**RE: TR A-1 Plat of TRS A-1 & A-2 Sunport Municipal Addn. (M16D024C)
2200 Sunport Blvd. SE
Grading and Drainage Plan
Engineers Stamp Date 8/26/2022**

Based upon the information provided in your submittal received 8/26/2022, the following comments must be addressed prior to approval:

Project Title: SUNPORT CELL PHONE LOT **Building Permit #:** BP-2022-22331 **Hydrology File #:** N/A

GRADING PLAN - AIS CELL PHONE LOT

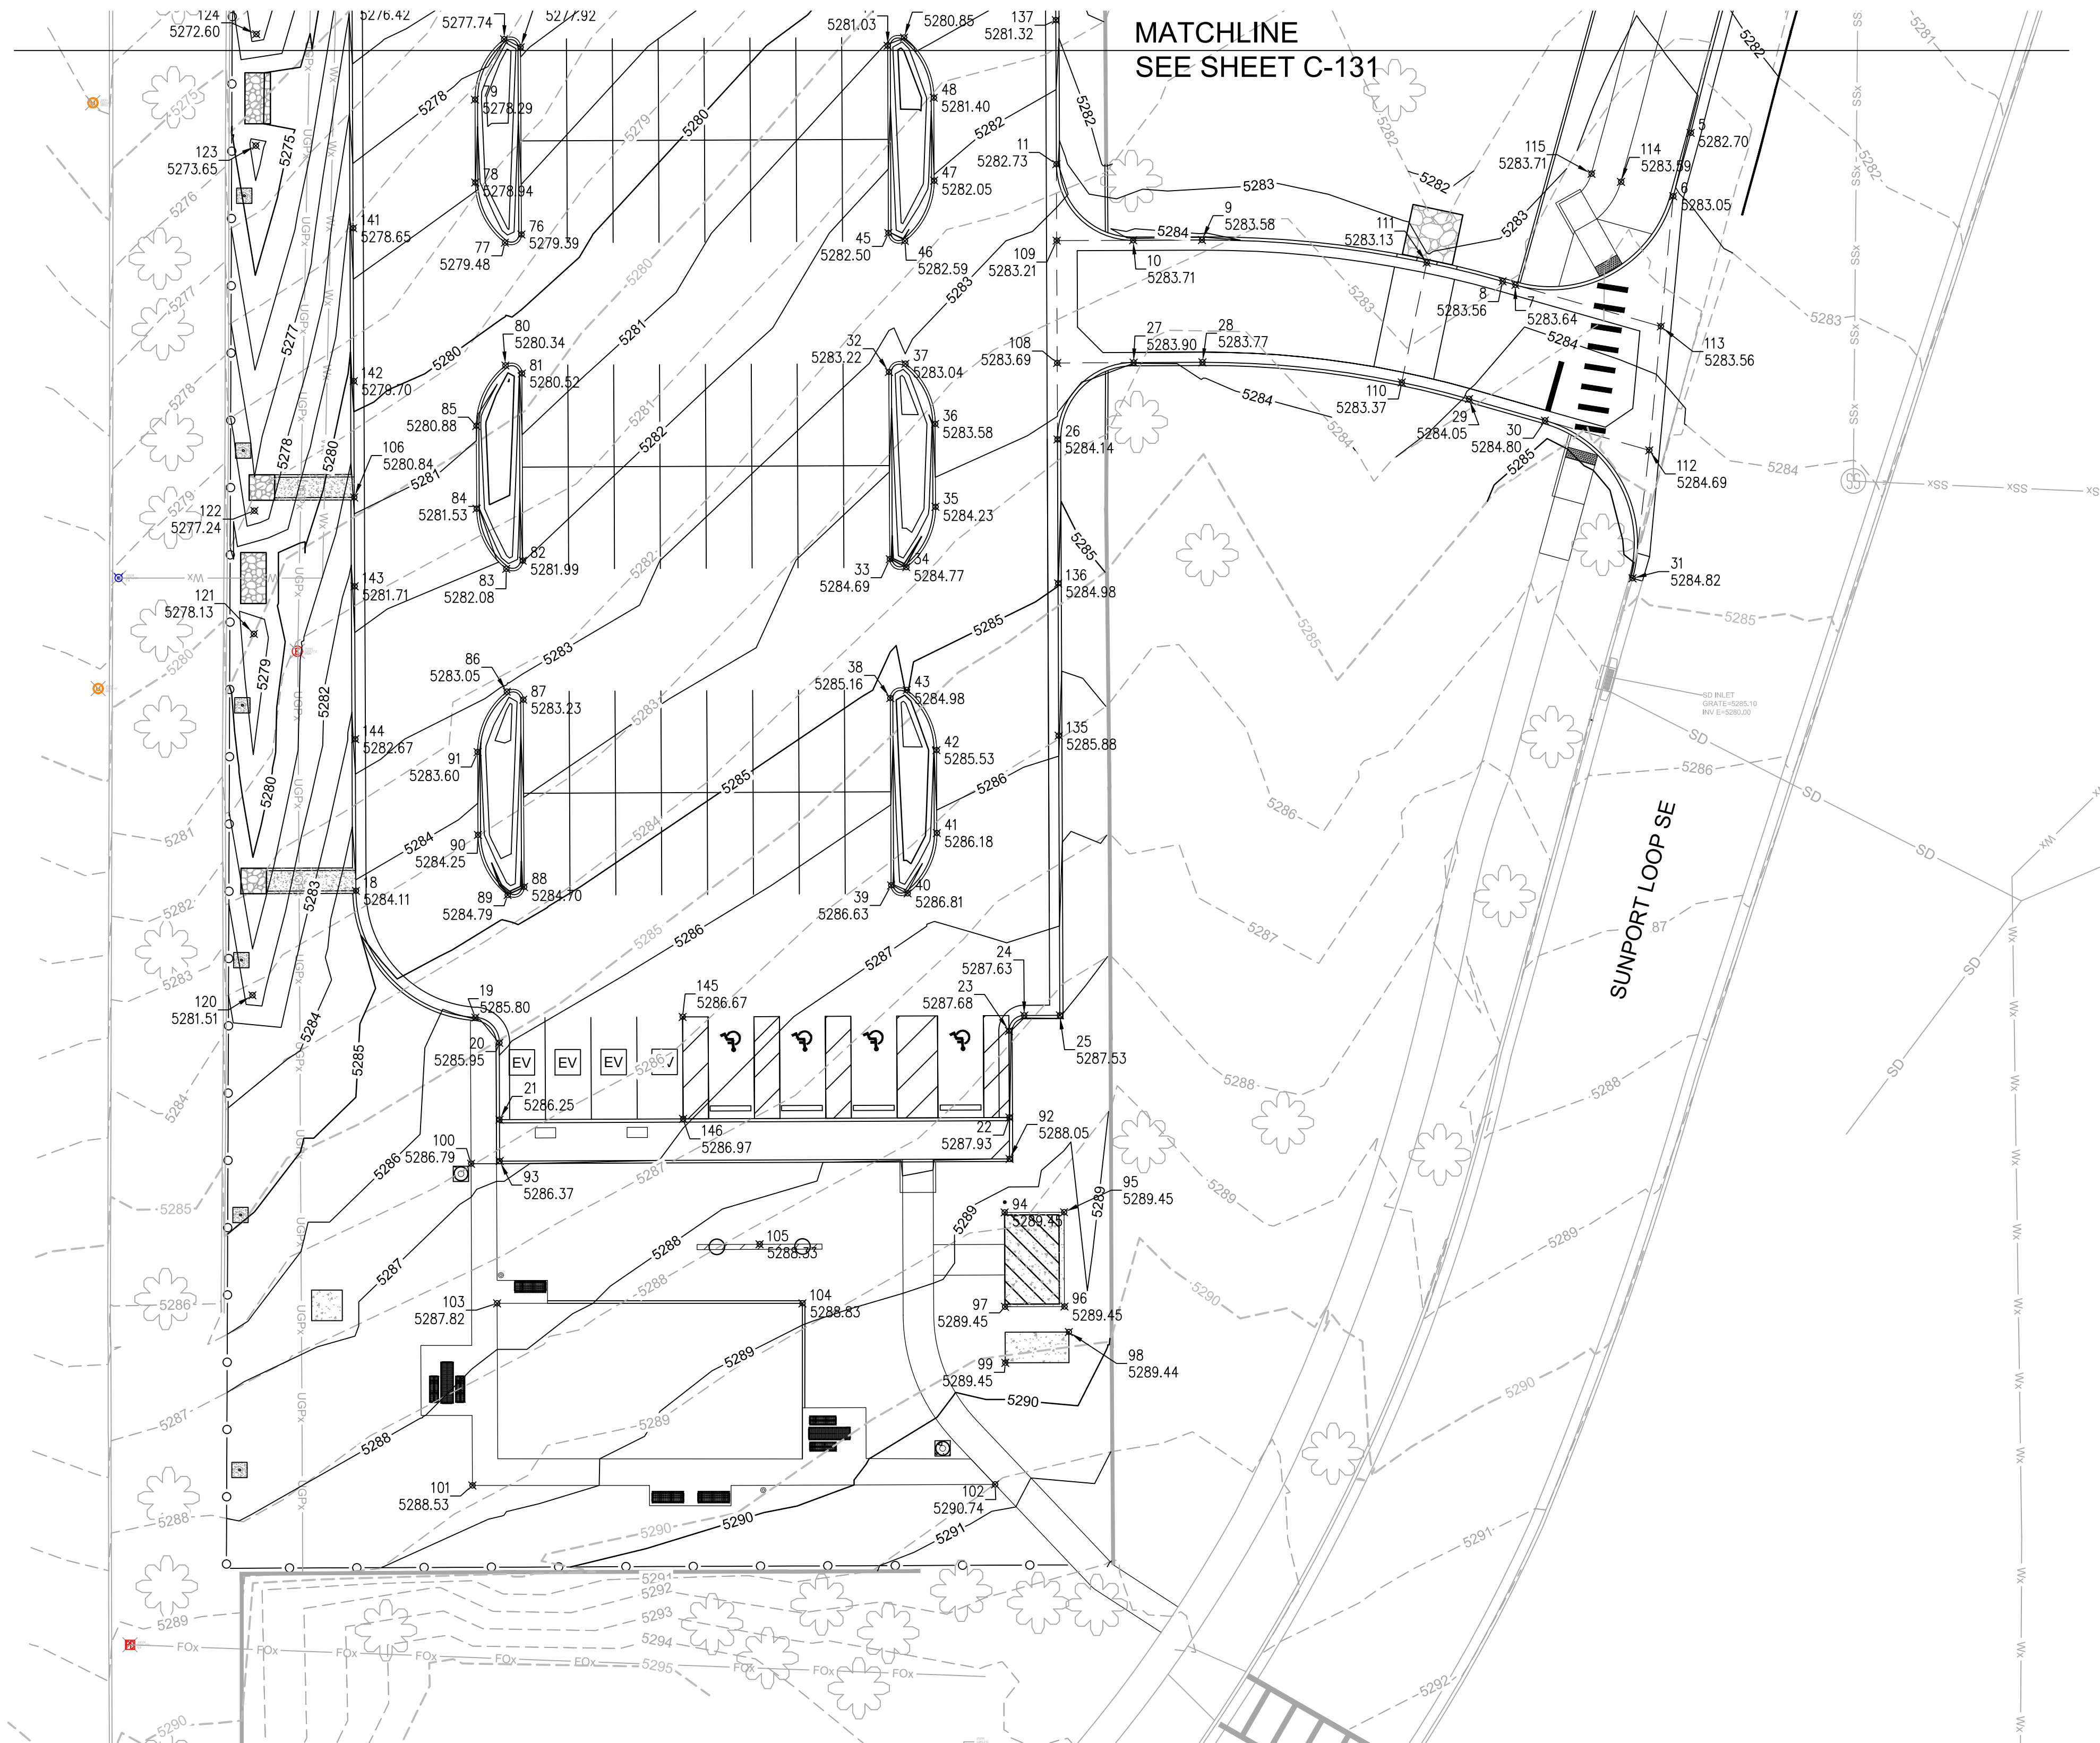
- 2) There is an existing area with buckled sidewalk just north of the start of deceleration lane.
- 3) There is an area were the runoff drains across the entrance. Please include riprap upstream of the low point as well.

- 5) Please provide more information about the existing inlet and provide inlet capacity calculations. Show spot elevations around the inlet to ensure runoff will not drain to the north instead of draining to the inlet. Please include a note that existing inlet to be cleaned (most likely full of sediment).

- 7) Was a Traffic Circulation layout submitted to Transportation for review and approvals?
- 8) Provide Finished Floor elevation for the restroom pad.

EXISTING DRAINAGE PLAN
 Scale: 1" = 40'

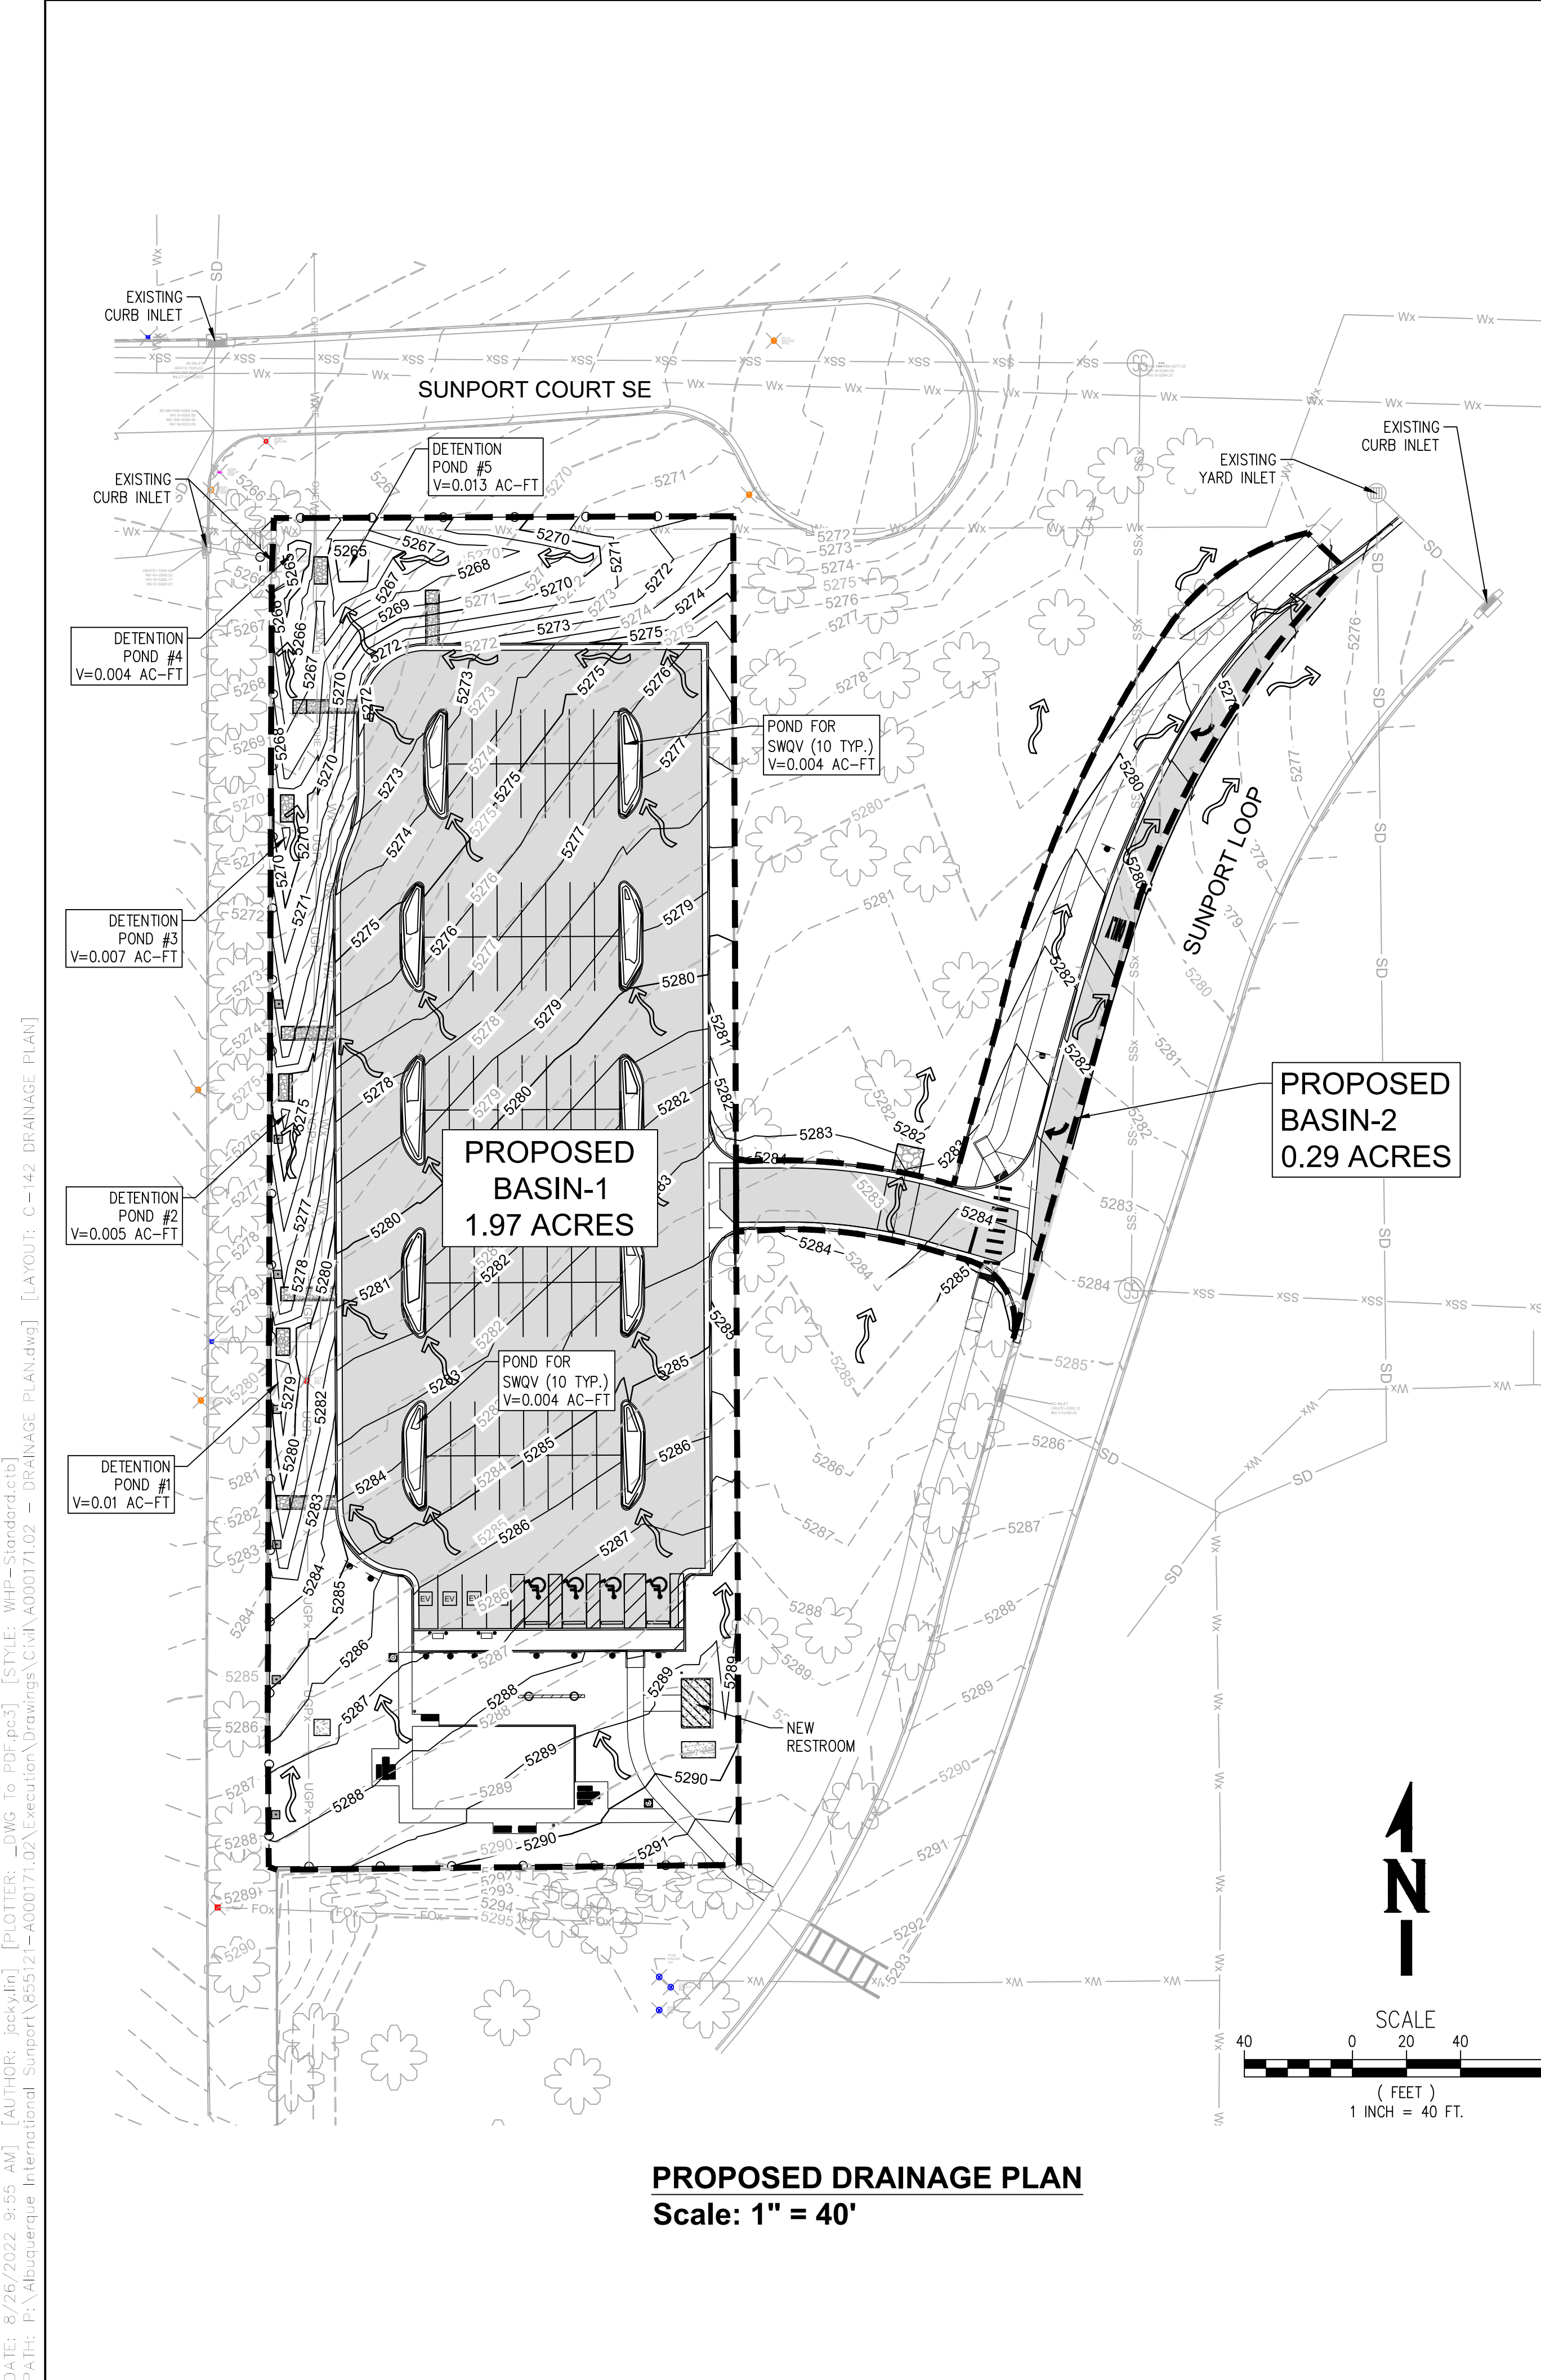
- 4) Please double check the treatment used in your runoff calculations both under the existing and proposed conditions. Under existing conditions, the treatment C is at 70%. It appears that the site is about 50% B. under the proposed conditions percentage D might be higher than show.
